Norfolk Vanguard Offshore Wind Farm

Natural England Position Statement at Deadline 7

Applicant: Norfolk Vanguard Limited
Document Reference: ExA; AS; 10.D7.22

Deadline 7
Date: 02 May 2019
Author: Royal HaskoningDHV

Figure 1: Broadland SPA / Ramsar study area (black dashed line) and onshore project area (red line). Red arrows indicate two separate sections of the onshore project area located within the Broadland SPA / Ramsar study area.

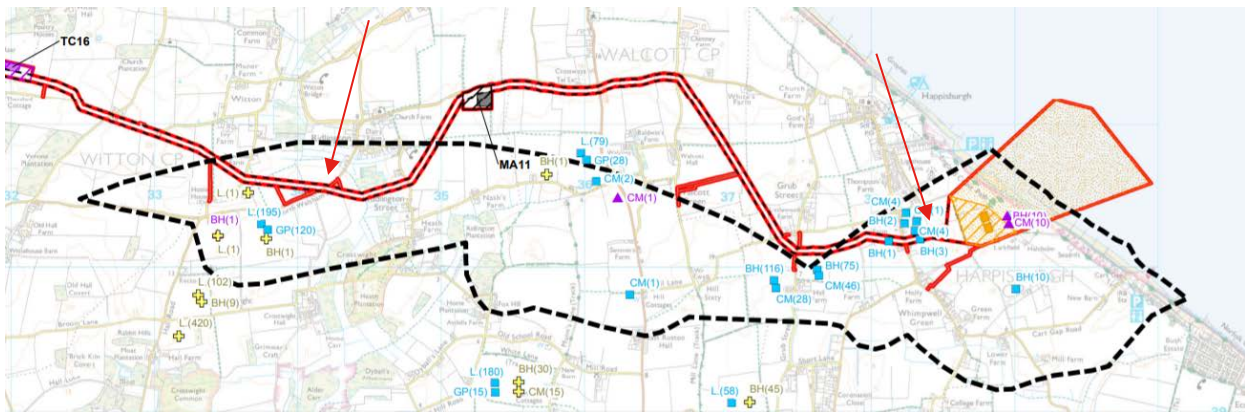
Broadland SPA/Ramsar site: This site was scoped out of the HRA on the basis that there was evidence of low levels of wintering birds associated with the SPA/Ramsar using the study area. However, this may have been due to the cropping regime at the time of survey. We requested that this point was taken account of by including additional measures, e.g. survey and/or WeBS data and information about predicted crop patterns at the time of the proposed work. We suggest that the Outline Landscape and Ecological Management Strategy (OLEMS) is amended to include further survey and provide suitable mitigation measures if required.

Measure 2: To be implemented if the second year of wintering bird surveys indicate significant numbers of wintering birds are present within the Order limits (and up to 300m buffer) within 5km of the Broadland SPA / Ramsar site.

Should intrusive works¹ be programmed between November and January (inclusive), only one of the two sections of the onshore project area located within the Broadland SPA / Ramsar study area (see Figure 1 below) would be worked on at any one time.

Proposed restrictions:
